A Partial Critique
of the
MoE
Feasibility Study on the Recycling of Used CANDU Fuel, April 2016
by the
Canadian Nuclear Laboratories

July 15, 2016

Peter Ottensmeyer PhD FRSC
Professor Emeritus
University of Toronto
peter.ottensmeyer@utoronto.ca

Figure 1. Graphical representation of the effect of one cycle of re-using UCF in CANDUs. Note different scales (arrows) for major amounts of used fuel (right axis) versus smaller amounts of FPs and TRUs (left).

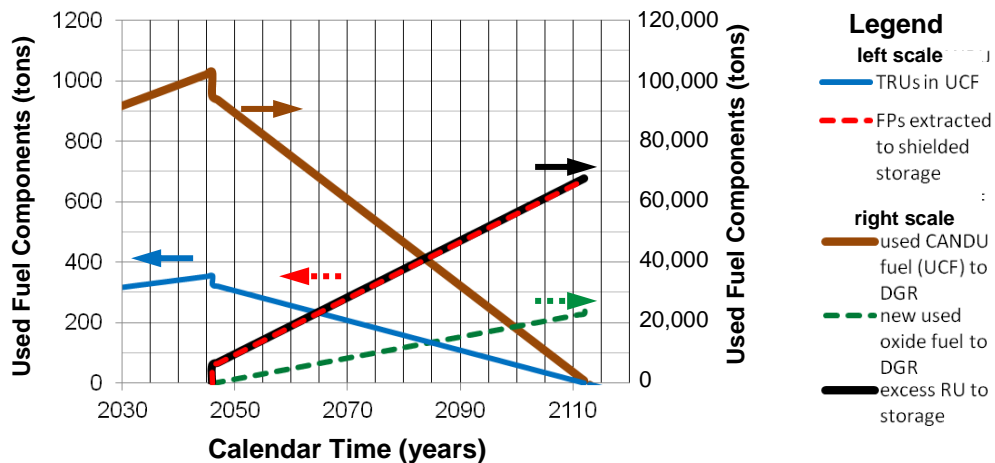
The effectiveness of this approach is shown graphically in Figure 1 to supplement Tables 1-3 and D-3 of the Study. For simplicity, to avoid complex time gaps during additional refurbishment, all refurbished CANDU reactors were considered to operate proportionately throughout the time period in the Study. Since the new MOX fuel (mixed oxide of Pu and U) required 1.1% fissile Pu compared to the 0.27% content of used CANDU fuel (UCF), about 4 volumes of UCF were required to create one new volume of MOX fuel. The excess processed uranium (RU) is stored. By the time all of the UCF is processed and its transuranics (TRUs) are passed through the CANDUs again, the material balance shows

0 tons used CANDU fuel	>>>>	no DRG required
~70,000 tons RU (pure reprocessed uranium)	>>>>	to storage
~700 tons extracted fission products (FPs)	>>>>	to shielded storage
~25,000 tons used MOX (used mixed oxide fuel).	>>>>	to DGR

Since the non-fissile component of the plutonium (Pu240/242) increased in this cycle relative to the fissile Pu239/241, further recycling is a process of diminishing returns. Without further recycling the 25,000 tons long-lived MOX UCF created would require long-term secure sequestering, i.e. a long-term DGR. The savings in terms of DGR space requirements are of the order of 25,000 tons compared to the original 103,000 tons. However the savings in costs would be a much smaller ratio. The potential fate of 70,000 tons of RU and 700 tons of fission products, not requiring a DGR, will be discussed below.

Figure 2. Graphical representation of Fuel Components in Option 3. Note different scales (arrow directions) for major amounts of CANDU used fuel and RU (right axis) versus smaller amounts of FPs and FNR used fuel (left).

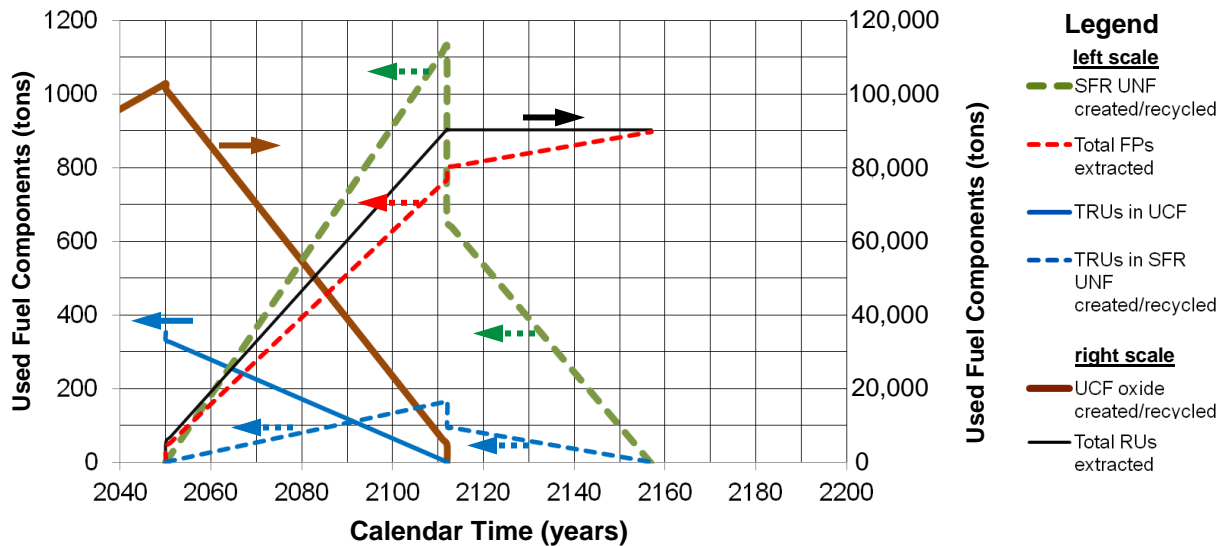
The second stage applied pyroprocessing to the used FNR fuel created in the first stage and to a small amount of used CANDU fuel remaining. The higher TRU concentration in the used FNR fuel permitted a much smaller pyroelectric-facility. The FNR fuel emerging from the reactors was then continuously recycled through 32 PRISM-like FNRs, again with a fissile conversion ratio of 0.5. The effectiveness of these two sequential approaches is shown in Figure 2.

up in quantity to 1130 tons. By year 2112, 800 tons fission products are extracted, as are just over 90,000 tons RU. At the end of this stage the used nuclear fuel that requires long-term sequestering in a DGR is reduced almost a factor of 20 from 103,000 to 5900 tons.

Used CANDU fuel	4770 tons	>>>>	to DGR
Used FNR fuel	1130 tons	>>>>	to DGR
RU (reproc. uran.)	90306 tons	>>>>	to storage
Fission products	770 tons	>>>>	to shielded storage

About one third of the accumulated 1130 tons used MOX fuel is required immediately to furnish starting fuel for the 32 FNRs (the major drop in the dashed green line at year 2112 in Fig. 2). The remainder of the used MOX fuel, plus any used MOX fuel emerging from the reactors, are recycled. After about two cycles all of the TRUs, both plutonium and the minor actinides reach a dynamic equilibrium at the end of each cycle, i.e. all added TRU isotopes are consumed in proportion. In about 45 years, around year 2155, the TRUs external to the reactors are eliminated.

The discussion of environmental aspects in the Study leaves much detail too opaque to assess the concluding rankings. For instance, Table 5-4 ranks Option 3 worst on the basis of 10,606 tons of high level waste left (HLW). The origins of that number are not at all clear. The mass balance analysis related to Fig. 2 (page 11, above), indicates 90,000 tons RU, 900 tons fission products, not counting the material

Figure 3. Graphical representation of Fuel Components in Option 3 with reactor configuration changed from CR=0.5 to CR=1.0. Note change of “in-reactor” fuel composition in year 2147.

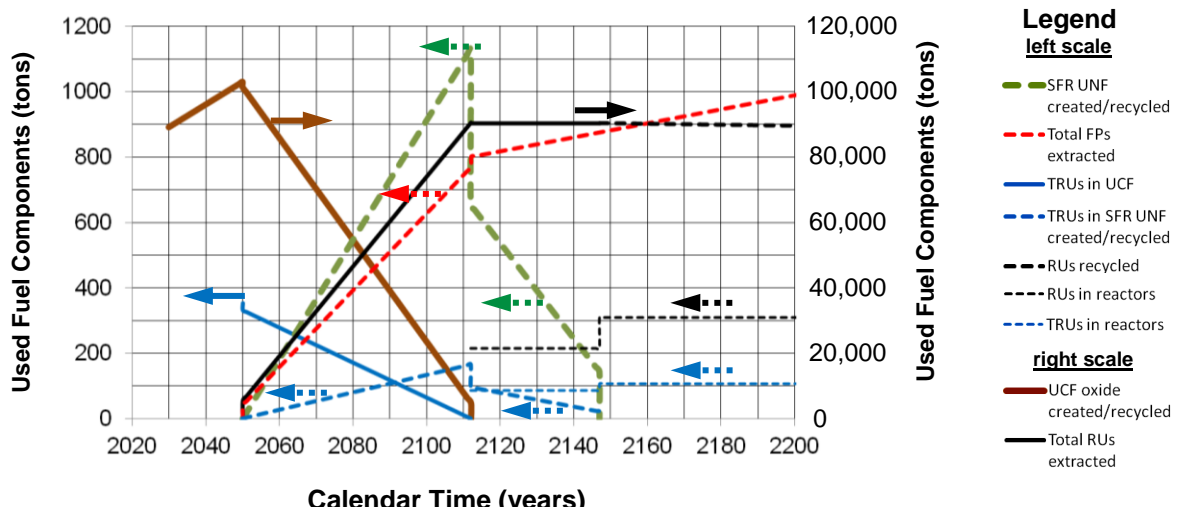
With some foresight the configuration of an FNR similar to the PRISM reactor can be changed from a conversion ratio (CR) of 0.5 to a CR of 1.0 without a redesign of the reactor core (see ref. 92 in Study: E. A. Hoffman, W. S. Yang and R. N. Hill, "Preliminary core design studies for the advanced burner reactor over a wide range of conversion ratios," Argonne National Laboratory, Argonne, 2006.). The change is accomplished by adding more uranium to the core, changing some peripheral reflector steel assemblies to RU-containing units, and by adding RU-containing rods above and below the fuel rods in the more central driver assemblies. In the vernacular of the field these changes add radial and axial "uranium blankets".

An additional change is a small absolute increase in fissile TRUs, although, as a ratio of the total core mass, the percentage fissile content is in fact lower. Nevertheless, it is important that this change occur while enough TRUs remain to satisfy these requirements. For Option 3 as is, the latest time is year 2147.

These changes are indicated in Fig. 3 by the “jog” in the “in-reactor” fuel components (thin dashed lines) at year 2147. Subsequent to this change the “In-reactor” TRU content and composition remain identical

The change in RU levels as it is used as fuel replenishment in FNRs with a CR=1.0 goes almost unnoticed at the time scale in Fig. 3 (dashed medium black line), since it is an annual change of only 14.8 tons in 90,000 tons per year. However, this change becomes quite obvious when the scale is expanded to many centuries (Fig. 4).

Figure 4. Graphical representation of Fuel Components in Option 3 with reactor configuration changed from CR=0.5 to CR=1.0 in year 2147. (extended time scale)

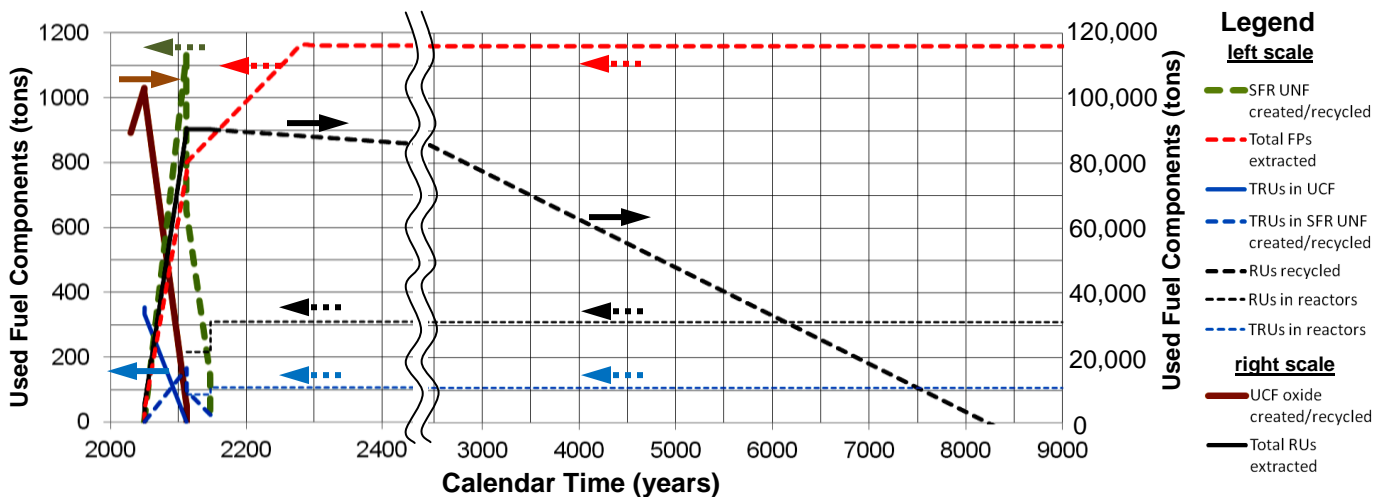
It is clear that the 90,000 tons of RUs could furnish over 8000 years of non-carbon power at a rate of ~116 TWh per year, at ~13 GW of electrical power using the equivalent of the 32 FNRs in the Study.

This would create at least 960,000 TWh additional electrical energy.

What is noticeable as well in Fig. 4 is the attainment of a constant level of fission products of just under 1200 tons close to year 2300 even with the power-creating production of new fission products. Since fission product radiotoxicity decays and attains background levels of uranium toxicities close to 300 years after discharge from a reactor (Fig.5), any fission products of that age can be treated effectively as

During recycling the major, pure uranium constituent, called reprocessed uranium (RU) in the Study, is extracted. As indicated in Fig. 4, it is a ready fuel constituent in FNRs with a CR=1.0. Therefore due to its value in energy production RU should not be disposed of permanently. Contrary to this conclusion, the CNL Study suggests that RU should be placed in the planned DGR, since it contains traces of fission products and U232, whose decay daughter Tl208 emits a 2.6 MeV gamma ray. Data below on RU and on fission products indicate such sequestering is not necessary.

Figure 5. Evolution of Radiotoxicity from Used CANDU Fuel Components Relative to Natural Uranium.

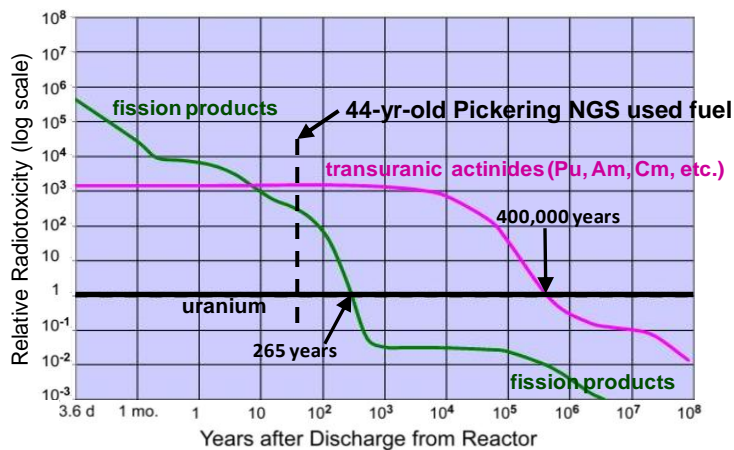
stable atoms and minerals. Thus any amount of new fission products discharged into shielded storage from any reactor at that time would be matched by an equal amount of fission product being released from storage as “non-radioactive”.

In irradiated CANDU fuel, the FPs in the fuel decay to a radiotoxicity level 1000 times uranium background in 10 years after leaving the reactor (Fig. 5), with Cs137 being the only gamma-emitting FP isotope after 30 years. Pyroprocessing provides uranium purities of the order of 1 part in 10^6 with respect to plutonium, with thermodynamics making it even more difficult for fission products to deposit with uranium (Till and Chang, Plentiful Energy, Amazon 2011, p. 194). Extraction of uranium in the various chemical processing schemes in the Study indicate high degrees of uranium purity as well. Therefore fission product impurities are expected to be small in RU. As a result “trace amounts” (p. 11-10 (108)) need to be defined in the Study before they can or should be used as a reason to discard a resource such as RU out of hand, with a cost of \$ 20-40 billions and a loss of many trillion dollars.

Figure 6. Distribution of amounts (black line) and values (green line) of fission products resulting from consuming 50,000 tons of nuclear fuel completely.

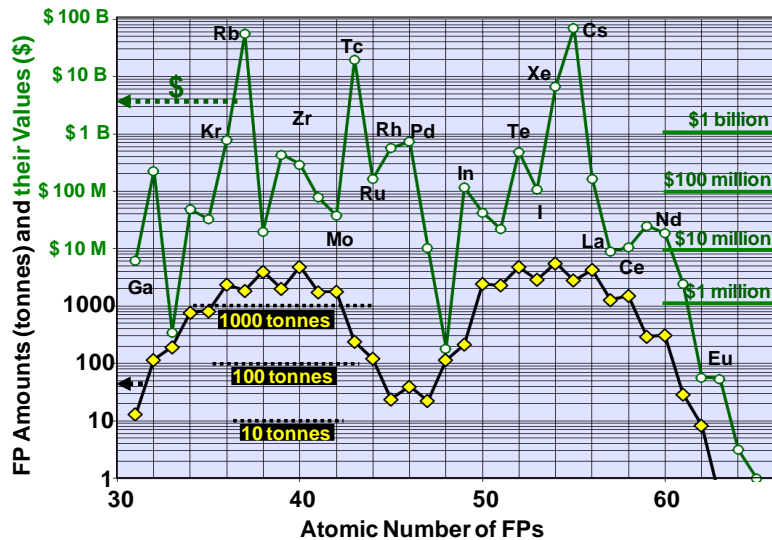
Fission products are in general considered to have a lifetime of the order of 300 years (Fig. 5), requiring safe shielded storage before that. They consist of elements in the central portion of the periodic table and are created in the reactor with a mass distribution shown in Fig. 6. They contain many valuable elements such as rare earths and platinum group metals of which rhodium and rubidium are stable non-radioactive elements immediately. Shown as well in Fig. 6 are the current values associated with the individual elements in proportion to their mass, as obtained from international vendors on the Internet.

The amounts add to about \$ 3 million per ton. After 300 years such elements can be extracted by ordinary means.

While the values in Fig. 6 refer to gross revenue, it is highly probable that extraction of elements will be a profitable endeavour. As an example, the platinum group metals, Rh, Rb, and Pd are at a higher concentration among the FPs than they are in the best ores in Africa; and FPs do not have to be mined.

It is therefore incumbent that the FPs not be sequestered permanently in a long-term DGR, but be stored safely and accessibly, and in a form that makes such future extraction economic. At a recent COG-OPG workshop on used fuel recycling Max Fratoni of the University of Berkeley suggested a solid salt form in stainless steel cylinders. This is preferable to the ceramic sodalite waste form suggested by the Argonne Laboratories that makes the fission products chemically virtually inaccessible (Till and Chang, p. 183).

Figure 7. Radiotoxicity of seven very-long-lived CANDU fuel fission products after discharge from reactor

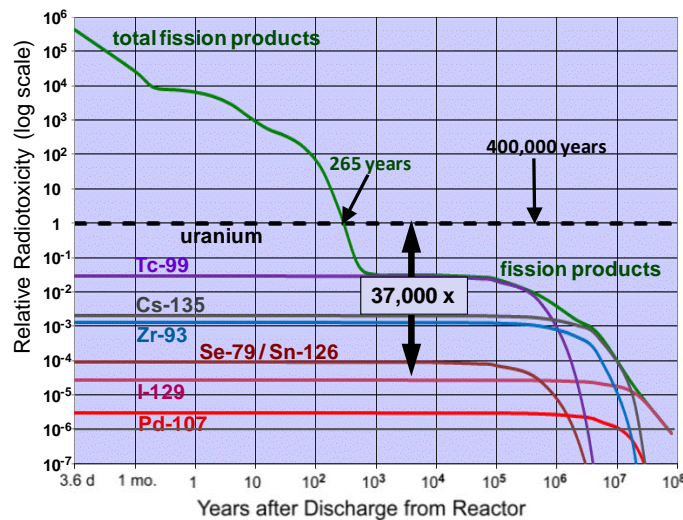
Figure 5 shows that some fission products at very low radiotoxicity have very long half-lives, of the order of a million years or more. These are shown in greater detail in Fig. 7. Of these, iodine-129 (I-129) with a 17 million-year half-life may be of biological concern even though its toxicity levels are almost 40000 times less than uranium, since ingested iodine can concentrate in the thyroid gland about 10000-fold [A. Taurog et al., J. Biol. Chem. 171, 1947, 189].

However, this particular concern can be alleviated as part of normal FNR fuel cycling. During pyroprocessing at 500°C, and again during casting and refabrication of new FNR fuel rods at about 1500°C, iodine, mainly I-129 and stable I-127, is volatile and is removed via condensation in cold-traps. I-129, with a neutron cross section of 30 b, can be transmuted in reactors to I-130, which has a half-life of only 12.3 hours, decaying to stable Xe-130. Some of the stable I-127 would become I-128, which decays in 25 minutes to stable Xe-128. Similarly, other iodine isotopes formed, e.g. I-130 to I-131, decay

rapidly to their stable xenon analogues. In this way a million-year concern becomes a 12.3-hour non-problem transmuting into a valuable noble gas.
